ADDENDUM NUMBER ONE

PROJECT: Pee Dee MHC Cabinet and Countertop Replacements

PROJECT NO: 20201223

1st Floor Group Room

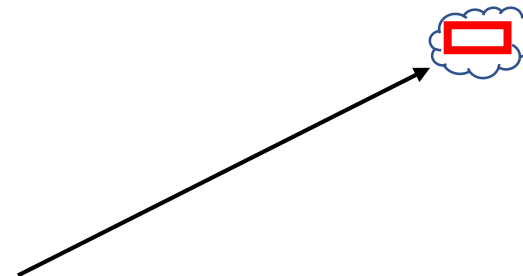
1. Locks will be required. Provide locks where indicated on attached drawings. Drawers and doors to receive locks are outlined in red. Locks shall meet the following requirements:

Board Room Break Area Cont'd

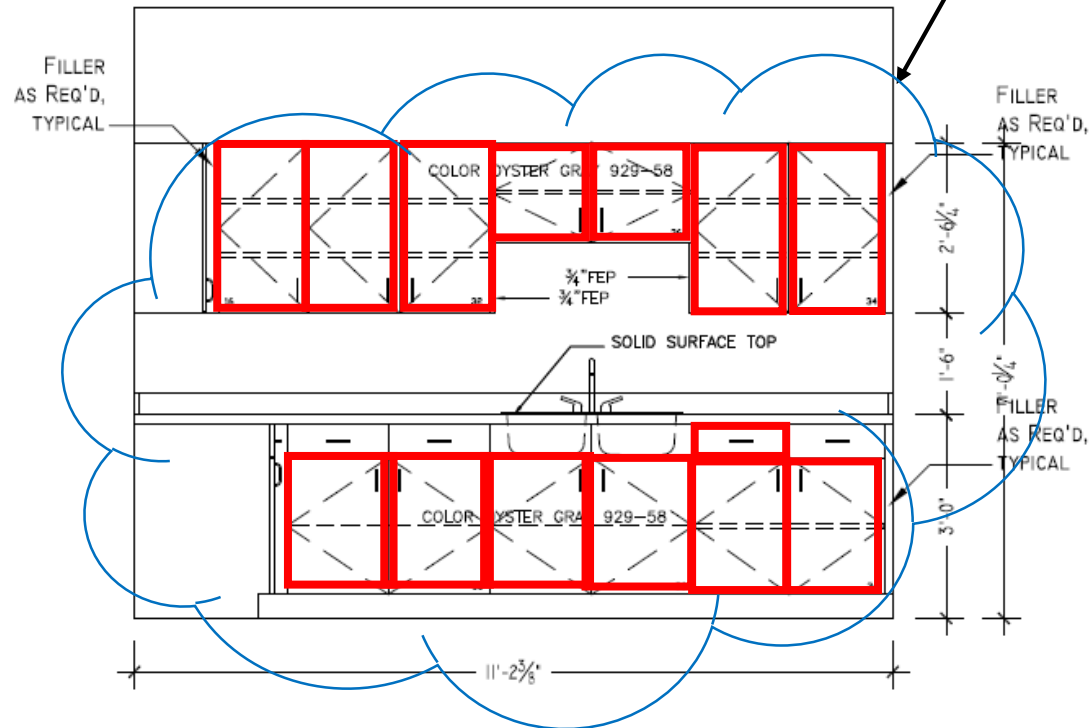
Add Locks
